ADDENDUM NO. 1
to
PLANS and SPECIFICATIONS
for

Medina River Sewer Outfall, Segment 4
SAWS Job No. 12-2504

Issue Date: March 2, 2012

**SAN ANTONIO WATER SYSTEM
MEDINA RIVER SEWER OUTFALL, SEGMENT 4
SAWS PROJECT # 12-2504
ADDENDUM NO. 1**

TYPICAL FIBERGLASS MANHOLE DETAIL
N.T.S.

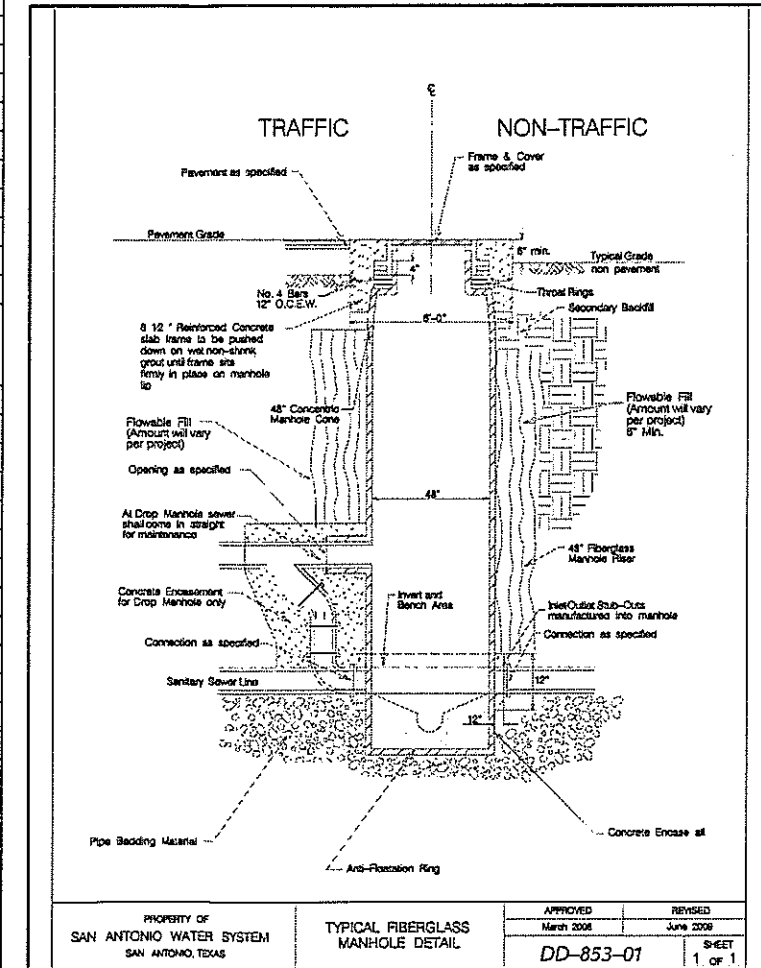
A. Drawing No. D-12, Sheet No. 64 – Have revised SAWS Detail DD-853-01. Remove and Replace this sheet with the attached plan sheet.

- D. Question: Do the fiberglass manholes need to be backfilled with flowable fill? The detail D-12-A on sheet 64 (DD-853-01), does not indicate that flowable fill is required. The SAWS Detail DD-853-01 per the SAW's web site indicates that flowable fill is required backfill? Do the Base Tee risers need to be backfilled with flowable fill?

Answer: Will need to comply with SAWS specifications. See item 4.A of this addendum.
